CITY OF MERCER ISLAND

**CRITICAL AREA DETERMINATION
NOTICE OF DECISION
August 7, 2017**

Project Number:	CAO17-006
Description:	Proposal to install improvements to stabilize steep slope and mitigate for a landslide. Proposal includes installation of 5,000 square feet of terraced garden, permeable surface walkways, 30" stack stone terrace walls, and metal stair from existing the parking area.
Applicant:	Cassidy Zimmerman SHKS Architects 1050 N 38 th St Seattle WA 98103
Owner:	Jeff Sanderson 8100 Evergreen Ln Mercer Island WA 98040
Site Address:	8100 Evergreen Ln, Mercer Island, WA, 98040; Identified by King County Assessor tax parcel numbers 8057000012 and 8057000014
Zoning:	R-15
SEPA Compliance:	A Determination of Nonsignificance (SEP17-014) is being issued concurrently with this decision.
Exhibits:	<ol style="list-style-type: none">1. Plan set dated May 18, 2017.2. Development Application dated May 18, 20173. Geotechnical Engineering Study, prepared by Geotech Consultants, Inc., dated June 16, 2017.4. Email from Don Cole, Building Official for the City of Mercer Island, dated July 21, 2017.5. Geotechnical review comments by Perrone Consulting, Inc., P.S. received July 19, 20176.

Shoring Plan
 Scale: 1/8" = 1'-0"

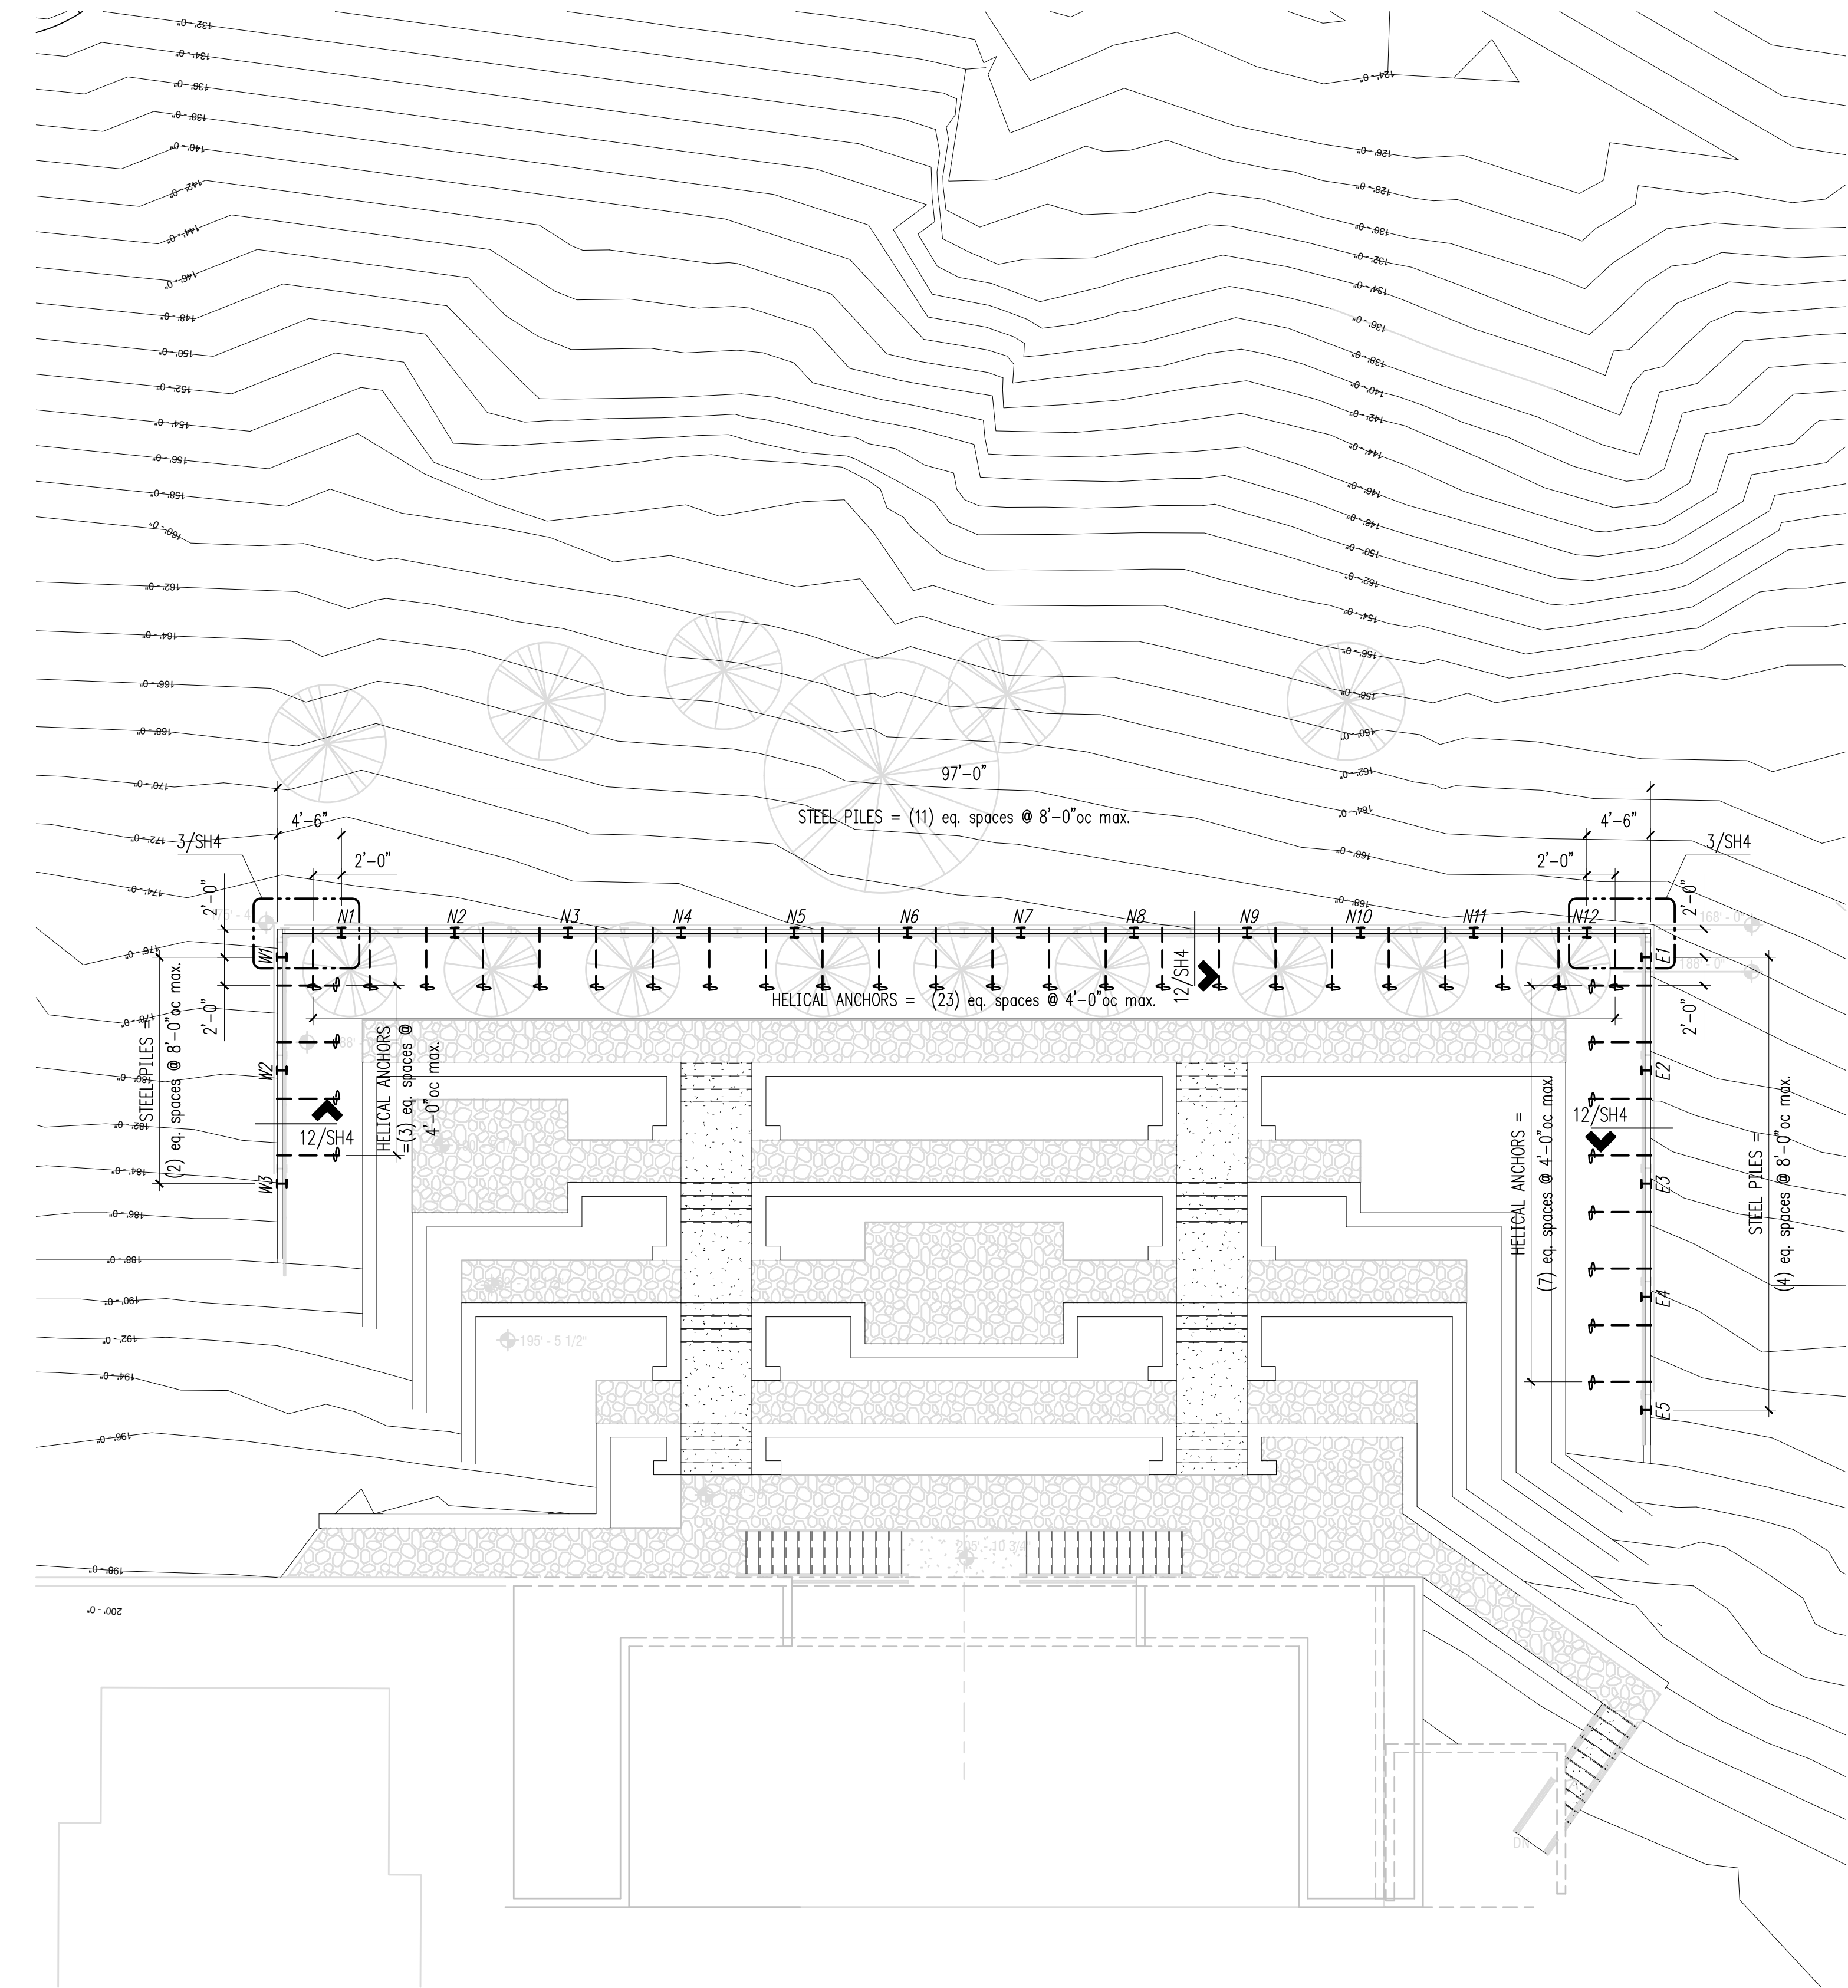
1. The design drawing SH1 references GCI report dated 3/29/2017 which I did not receive for review.
2. GCI should provide allowable end bearing capacity for soldier piles based on the proposed embedment depths.
3. Helical anchors are permanent (not temporary as stated on page 7, paragraph 4) and should be specified as galvanized for corrosion protection.
4. GCI report recommends using native soil as structural backfill (page 8, paragraph 6). However, this does not seem practical since they are fine-grained soils and do not satisfy the gradational requirements specified in GCI report (page 8 paragraph 1). The design drawings, however, show imported free-draining granular backfill which is more appropriate.
